Date: October 27, 2022

Subject: ADDENDUM #2

Project: Transition Building
(T99) Addition

Project No: 220082

2 KITCHEN CASEWORK SECTION AT ADA SINK
SCALE: 1" = 1'-0"

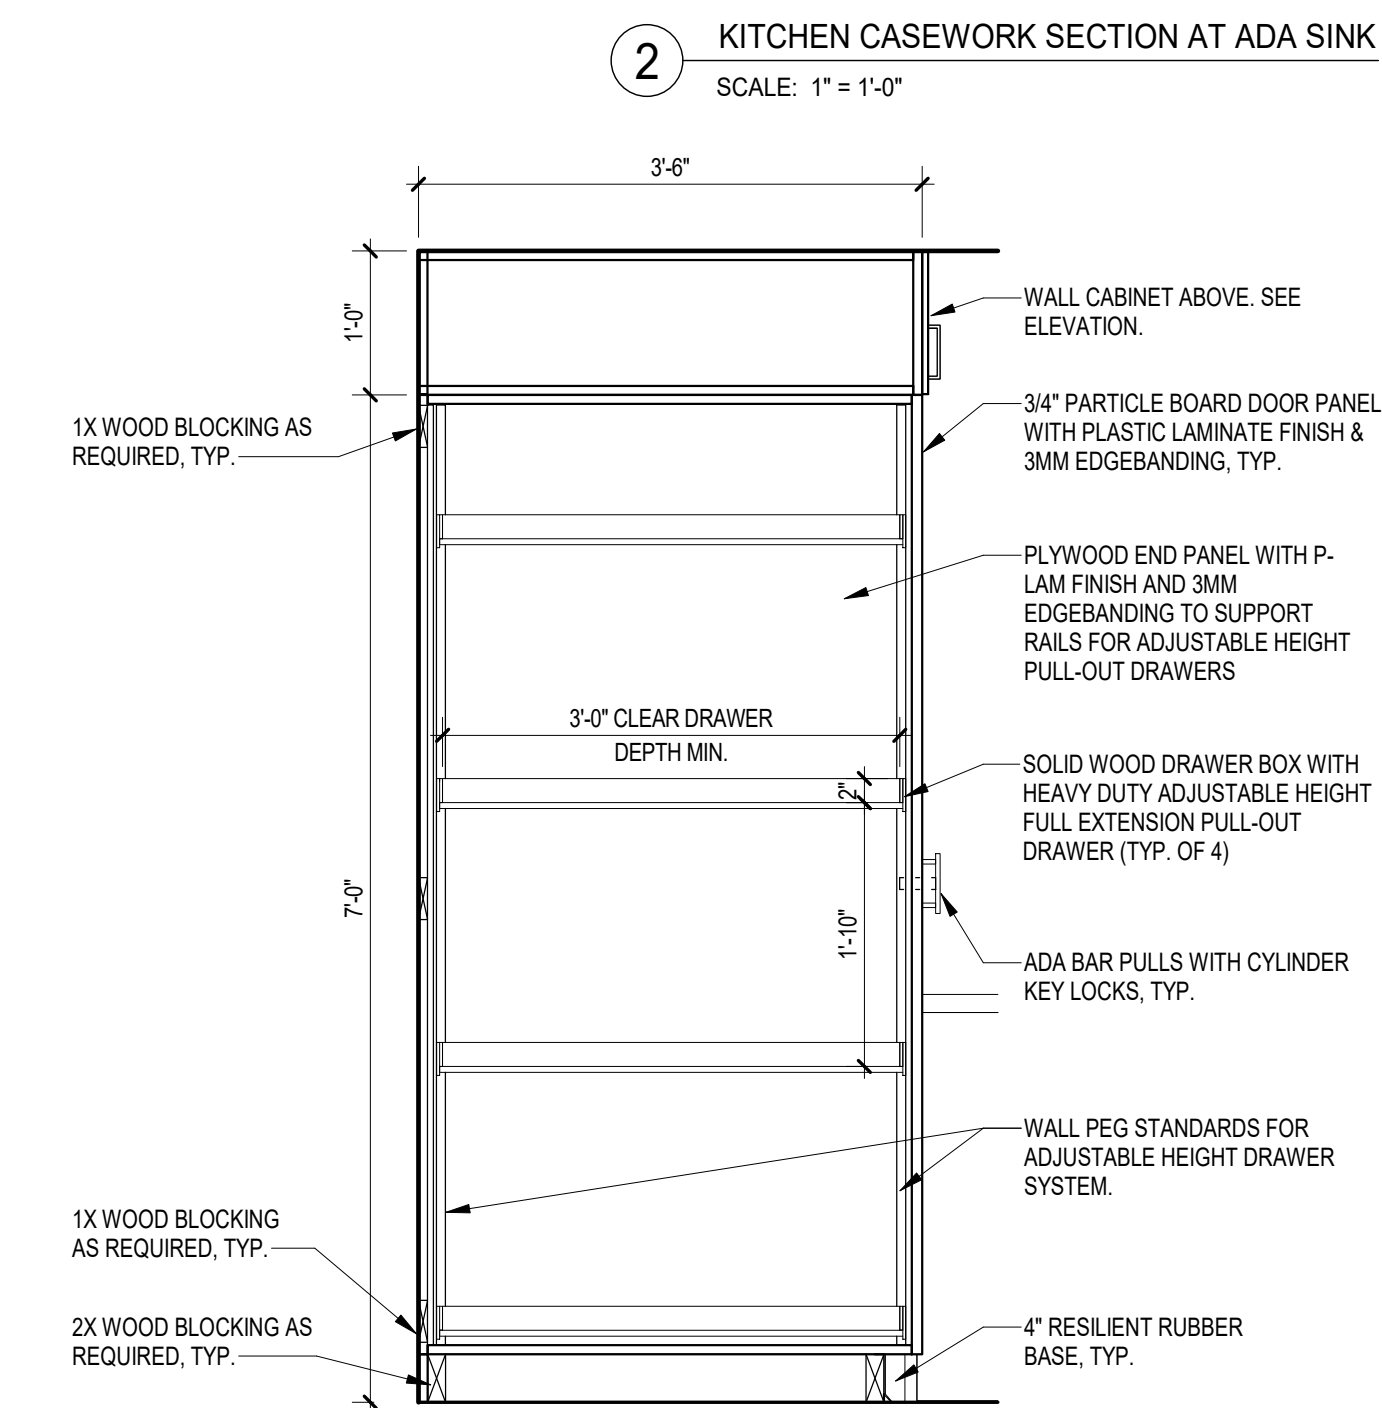
- Added required clearances for ADA at sink casework section detail no 2.

SIGNAGE PLAN &
DETAILS

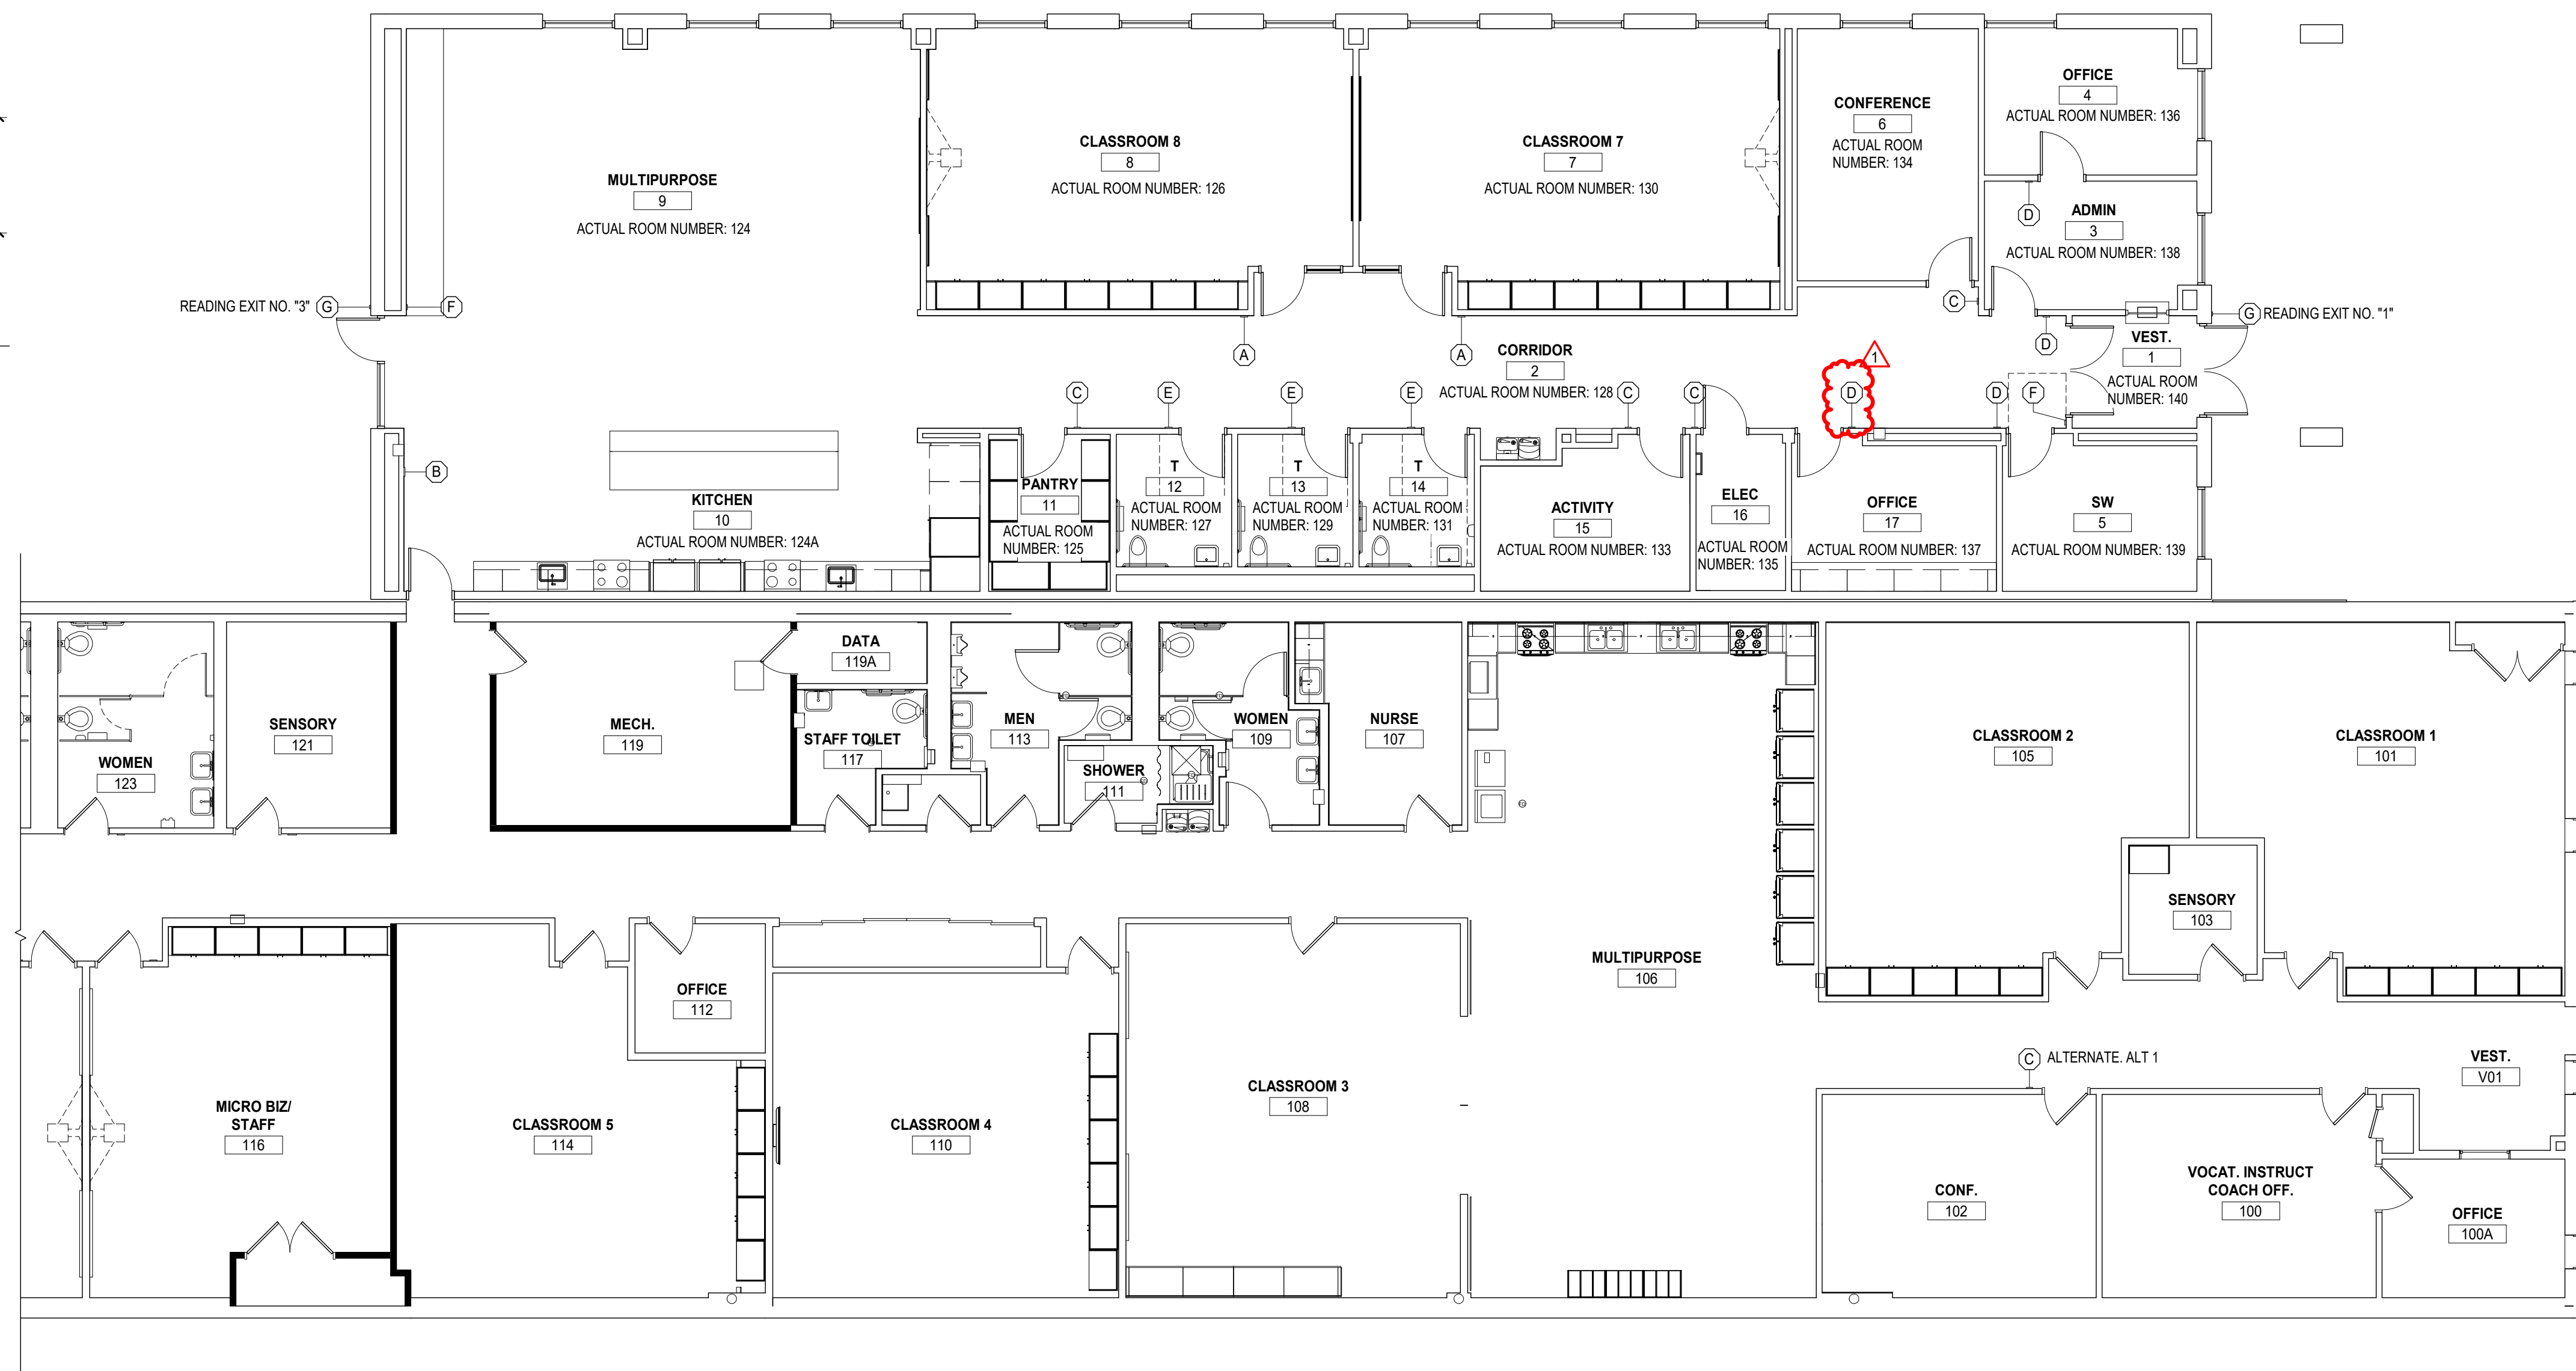
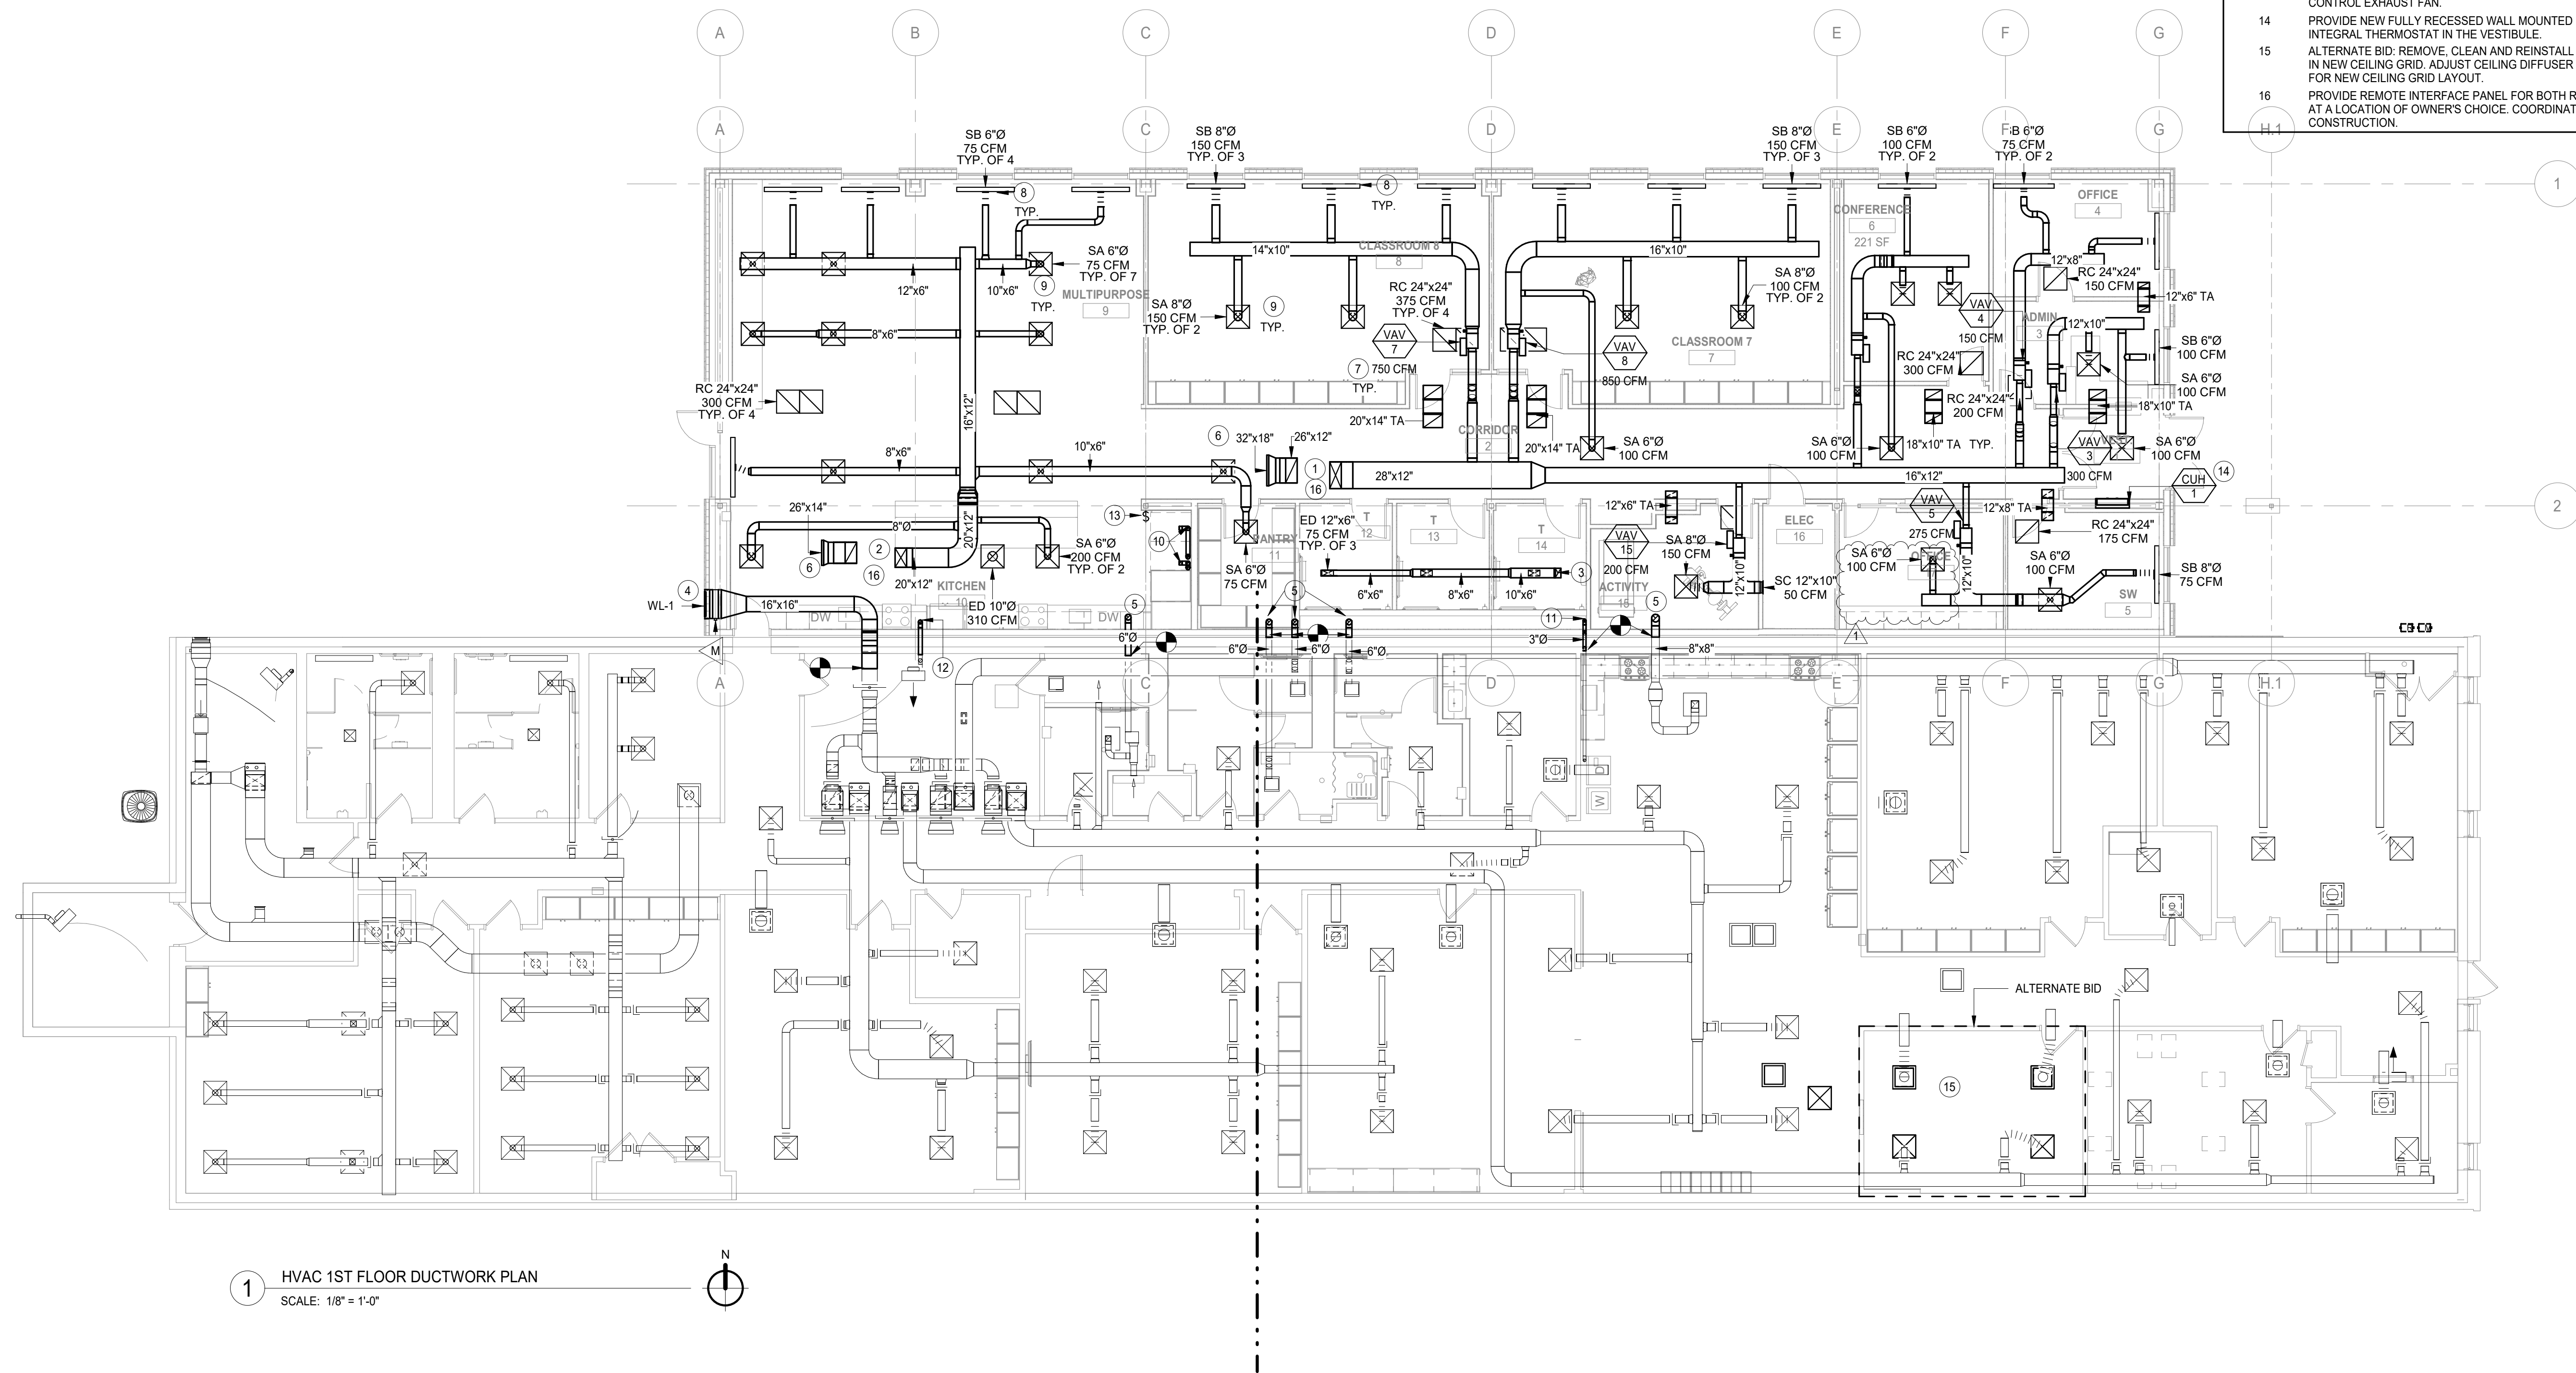
- Revised Office (room no 17) signage type.
